NUSCALE POWER, LLC

SAFETY EVALUATION FOR NUSCALE TOPICAL REPORT, TR-0915-17772, REVISION 3, “METHODODOLOGY FOR ESTABLISHING THE TECHNICAL BASIS FOR PLUME EXPOSURE EMERGENCY PLANNING ZONES AT NUSCALE SMALL MODULAR REACTOR PLANT SITES”

Figure 1: GMRS for the sites selected for the NRC staff's evaluation and NuScale's CSDRS

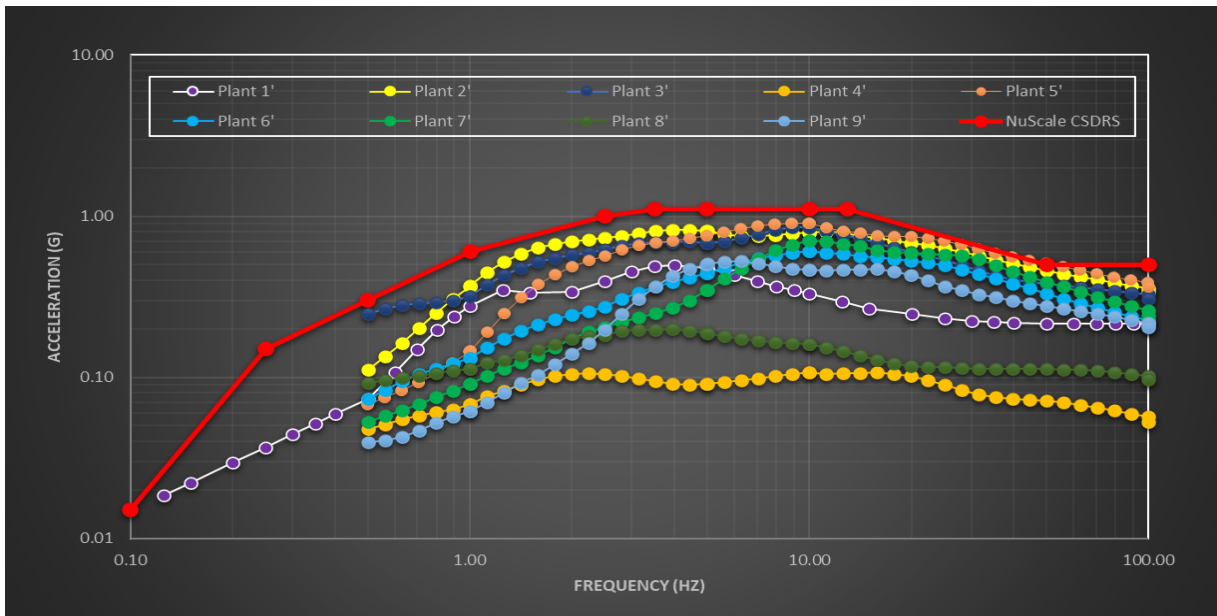
}} The NRC staff evaluated the size of the "risk gap" based on nine plant sites

within the NuScale Certified Seismic Design Response Spectrum (CSDRS). Specifically, the NRC staff evaluated the percentage and absolute value of seismic CDF that would be excluded from EPZ sizing. Consistent with NUREG-0396, the objective of the NRC staff's evaluation was to ensure that a seismic risk was captured for consequence analysis to: (1) include an adequate amount of seismic events in the spectrum of accidents for EPZ sizing, and (2) to include some of the key characteristics of large releases from seismic severe accidents. Further, as discussed above, WASH-1400 and by extension NUREG-0396 did not include quantitative seismic risk estimates in the dose-distance calculations. Due to these constraints, the seismic CDF was used in the NRC staff's evaluation of the adequacy of the {{
}}

Step 1: The NRC staff identified nine (9) operating reactor sites to provide a sufficiently large representation of seismic hazards across the contiguous US and collected the mean seismic hazard curves for these sites. The sites include the Western US (WUS) and the Central Eastern US (CEUS) with different site characteristics. The seismic hazard information used for each site includes the mean hazard curve at various spectral frequencies (e.g., 0.5 Hz, 1 Hz, 2.5 Hz, 5 Hz, 10 Hz, and 100 Hz) and the ground motion response spectrum (GMRS). The latest re-evaluated seismic hazard information was used for each selected site. The sites were selected such that the GMRS for each site was bounded by NuScale's CSDRS for the horizontal direction provided in Table 3.7.1-1 of the NuScale Final Safety Analysis Report (ML20224A484). Figure 1 shows the GMRS for the sites selected for this case study and the CSDRS. The GMRS was used to determine the spectral ratios representing the ratio of the acceleration at a particular frequency to the acceleration at peak ground acceleration (PGA; 100 Hz) (see ML100270582 for details on deriving spectral ratios). An example of the derived spectral ratios is provided in Table 2.

Step 2: The NRC staff used the NuScale high confidence of low probability of failure (HCLPF) plant level fragility (PLF) of 0.84g anchored to the PGA. This HCLPF PLF is based on the NuScale FSAR Section 19.1.5.1.2.

Step 3: The NRC staff convolved the hazard curves at different frequencies with the PLF to estimate the seismic CDF. The convolution of hazard curve and PLF is a well understood and widely used method of estimating the seismic CDF (e.g., see Results of Safety/Risk Assessment of Generic Issue 199, "Implications of Updated Probabilistic Seismic Hazard Estimates in Central and Eastern United States on Existing Plants" ADAMS Accession number
